**REGULATIONS Nos. 13 AND 13-H (Braking)**

**INDIA’S COMMENTS ON PROPOSED AMENDMENTS TO REGULATIONS No. 13-H**

Figure 2: Example of test 2 of a category "B" BAS system

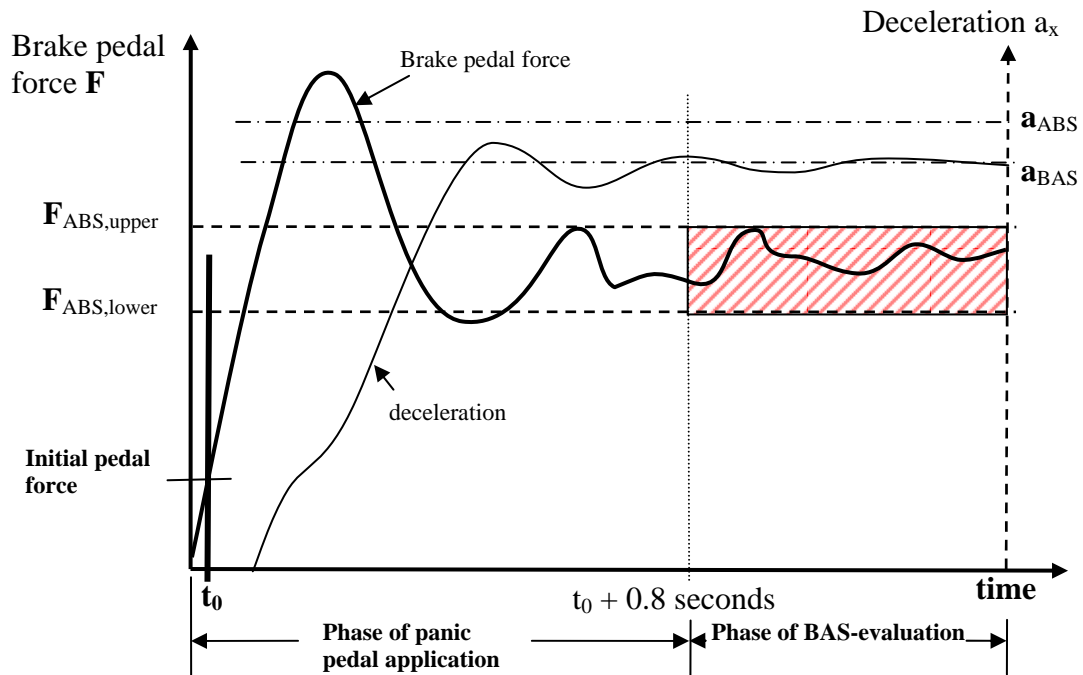
**4.3. Data evaluation**

The presence of BAS 'B' is ~~proven~~ *proved* if a mean deceleration ( $a_{BAS}$ ) of at least  $0.85 \cdot a_{ABS}$  is maintained from the time when  $t = t_0 + 0.8$  s to the time when the vehicle speed has been reduced to 15 km/h.
